Commissioners Comments and Questions

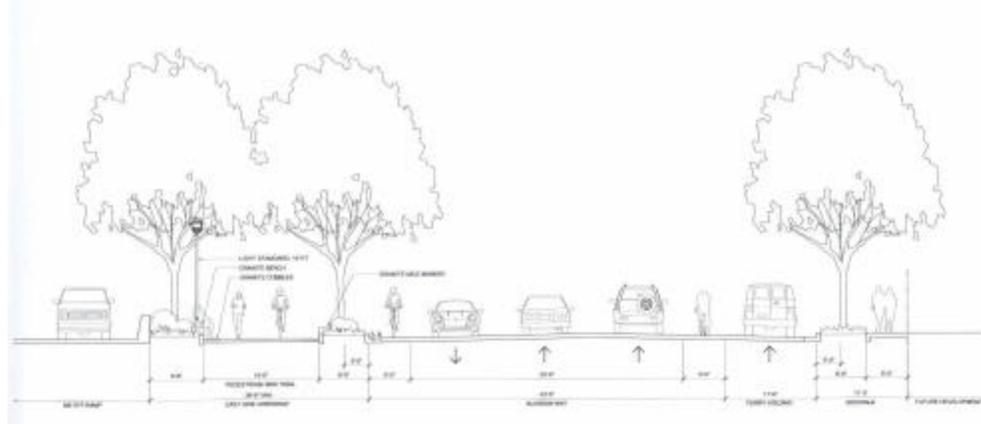
Is the tail track in its existing location?

What are the stripes?

Is there a reason the trail is 18 inches below grade?

There is a confusing intersection where the southbound lane splits off; a right angle is preferred.

No, it is relocated.

It is a planting pattern including Rhododendron, mondo grass, and sword fern, intended to create different planting layers.

It is intended to provide a sense of continuity with the trail pattern.

To create a seating area
